**Department of
Environmental Protection**
Western Regional Office

Re: Amherst-DWPC-Title 5
Variance-Mandle
Transmittal # 58599
Project # 94-251

PROPOSED SEPTIC REPAIR PLAN FOR
DIAN MANDLE 351 POTWINE LA.,
AMHERST, MA.

Drawing Number 94-404-0822, Date: 10/21/94

PROPOSED SEPTIC REPAIR PLAN FOR DIAN MANDLE 351 POTWINE LA., AMHERST, MA.		
SCALE:	APPROVED BY	DRAWN BY AW
DATE: 10/21/94		
COLD SPRING ENVIRONMENTAL, INC. BELCHERTOWN, MA. 323-5957		
DRAWING NUMBER 94-404-0822

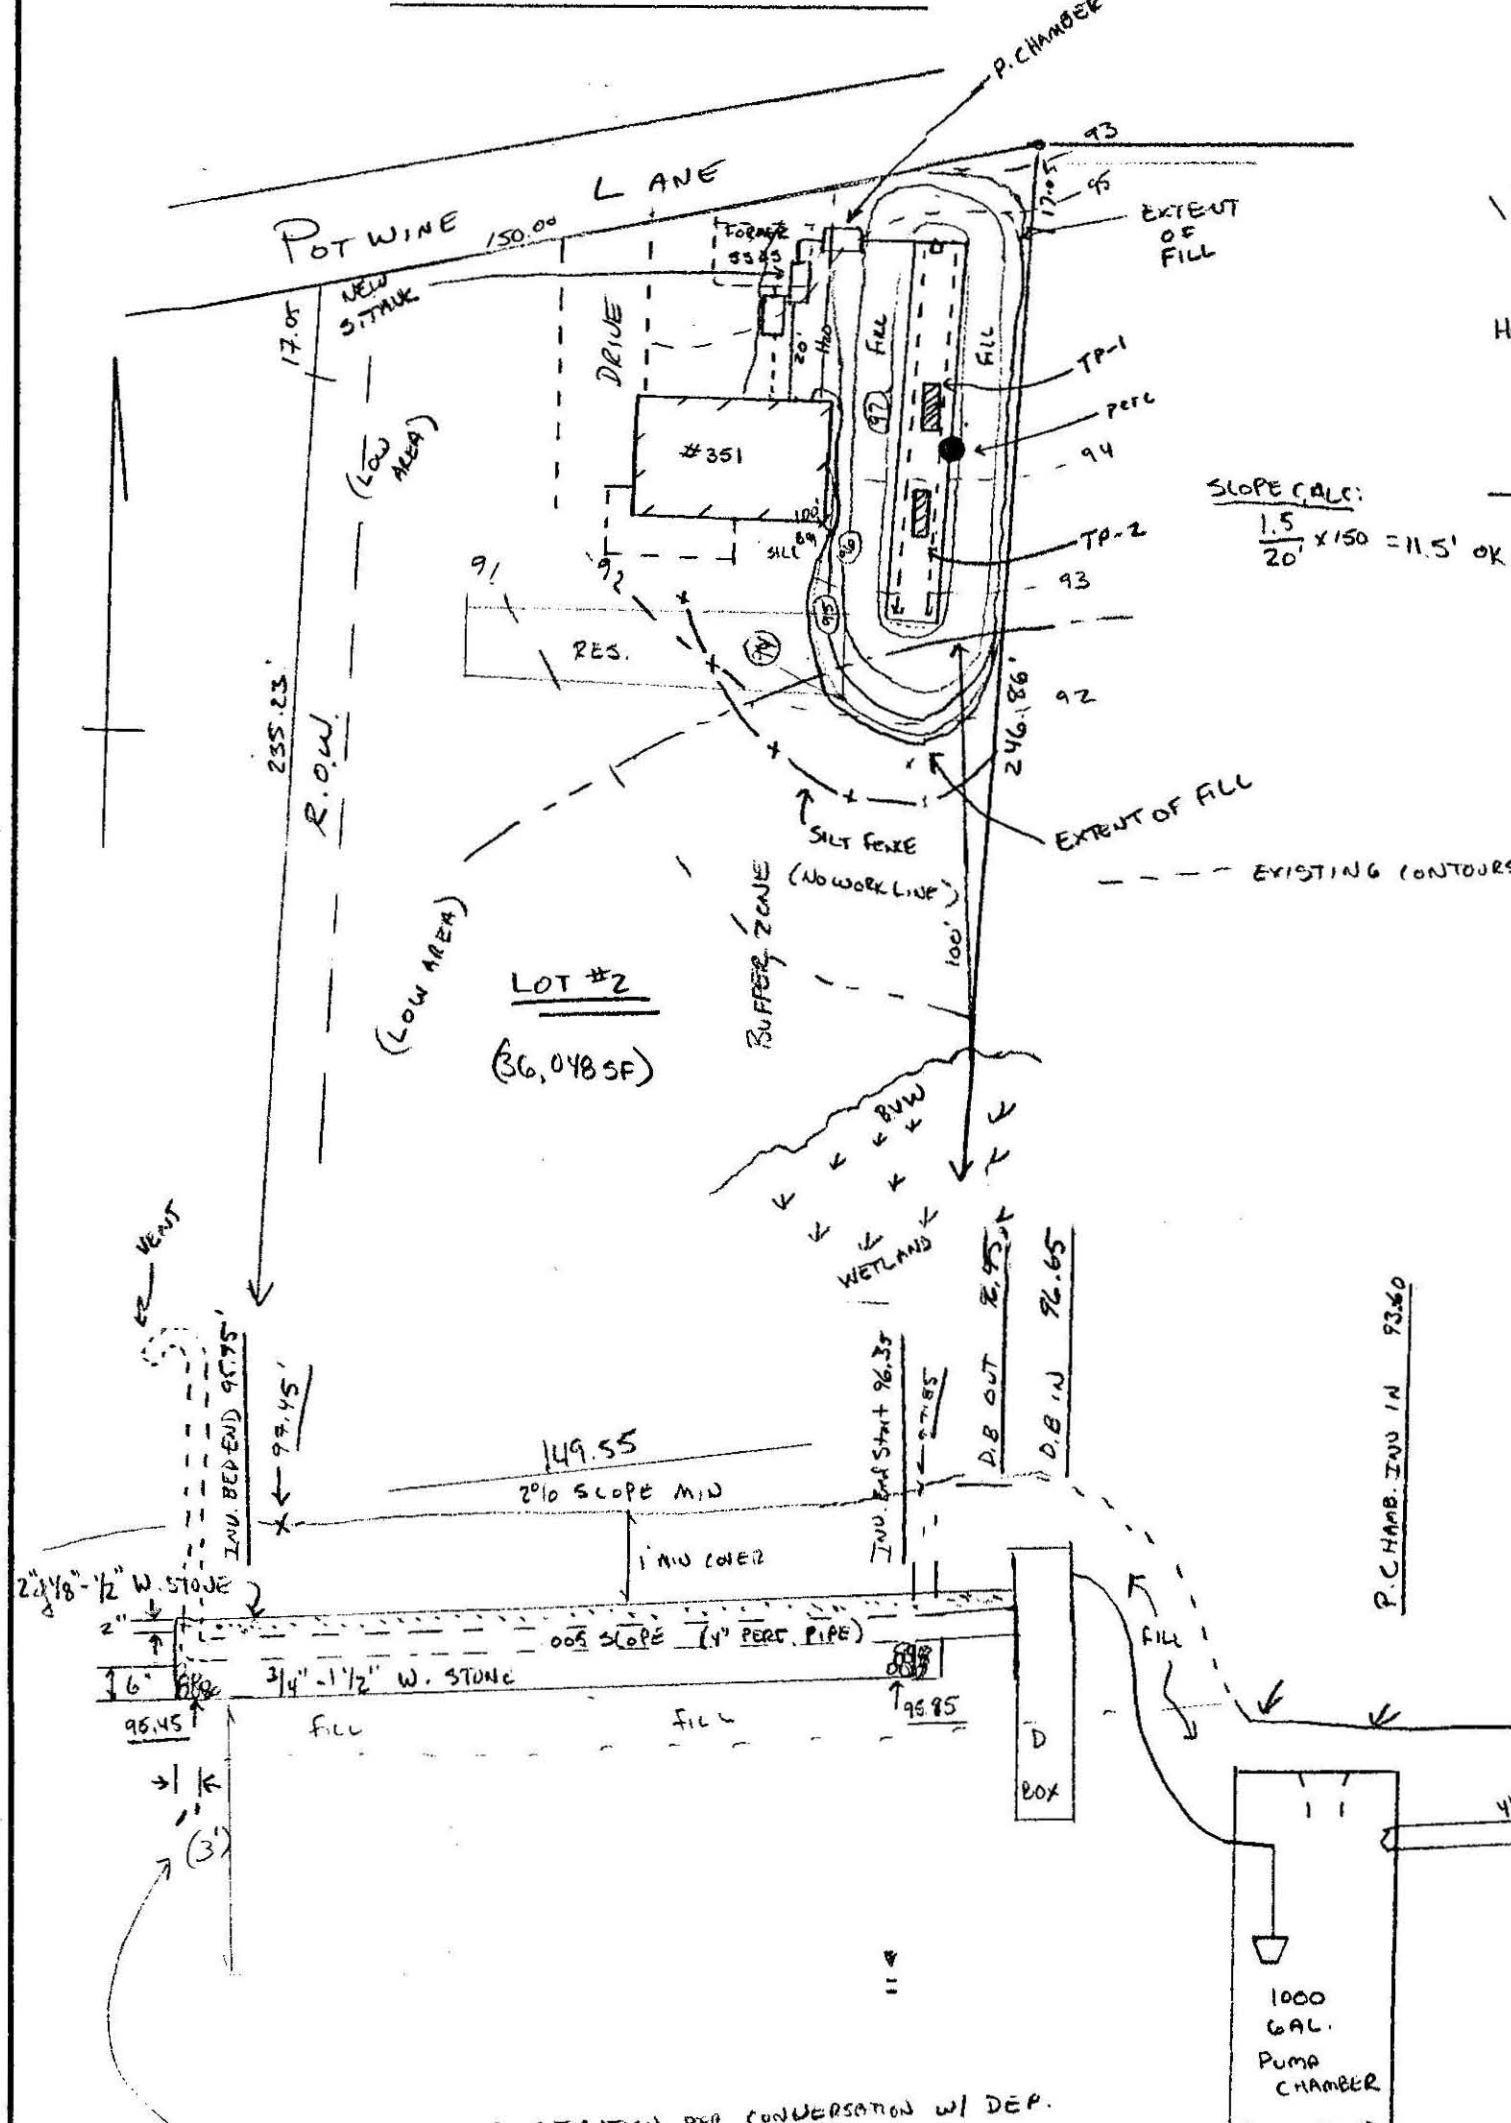
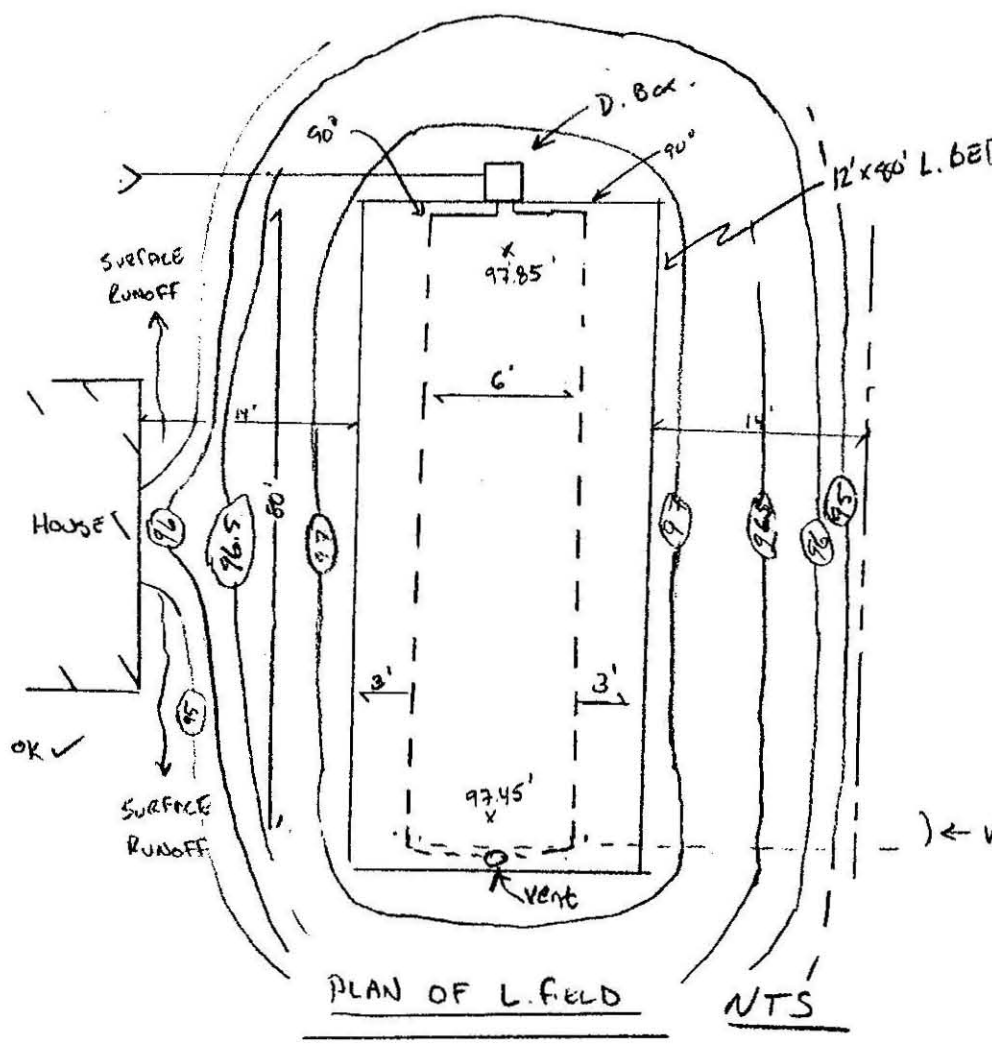
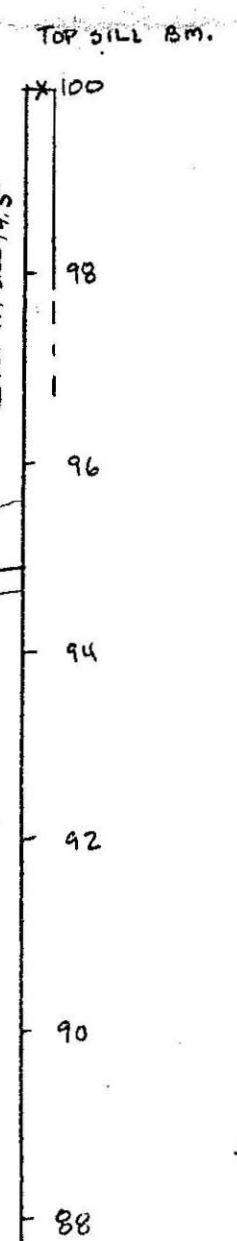
The plan received by the Department on November 18, 1994 proposes to replace the failing subsurface disposal system at this existing four bedroom home with a 1,000 gallon septic tank, a 1,000 gallon dosing tank, a distribution box and 960 square feet of leaching bed. The design for the leaching facility is based on an 8.0 minute per inch percolation rate. The Amherst Health Department submitted an approval for the variances requested in a letter dated November 19, 1994.

1. 310 CMR 15.02(17) Due to the limited lot size, the requirement to remove impervious materials for 25 feet around the leaching facility cannot be met. Excavation to remove impervious materials can only be done for 10 feet for this leaching facility.
2. 310 CMR 15.03(6) Due to the limited lot size and high seasonal ground water elevation, the leaching facility will be constructed in fill to meet the separation distance requirement. However, due to problems relating to surface water run off, the designing sanitarian has proposed to construct the leaching facility with three feet separation to the maximum ground water elevation instead of the four feet required under Title 5.
3. 310 CMR 15.03(7) Due to the limited lot size, distance from leaching facility to cellar wall will be 14 feet instead of the required 20 feet.

The Department acting in accordance with the provisions of 310 CMR 15.20 hereby approves of these variances subject to the following provisions:

- 1) That a Disposal Works Construction Permit be obtained from the Amherst Health Department prior to the start of construction.
- 2) That no changes be made in the approved plan without the prior written approval of the Department.
- 3) That the designing sanitarian certify in writing to the Amherst Health Department with a copy to this office that the system has been constructed in accordance with the approved plan prior to the system being used.
- 4) That a notice be placed with the deed and recorded in the appropriate Registry of Deeds indicating that the subsurface disposal system for this property required variances to Title 5. A copy of the notice to the deed must be submitted to the Department within 30 days of the date of this letter or the approval will no longer be valid.
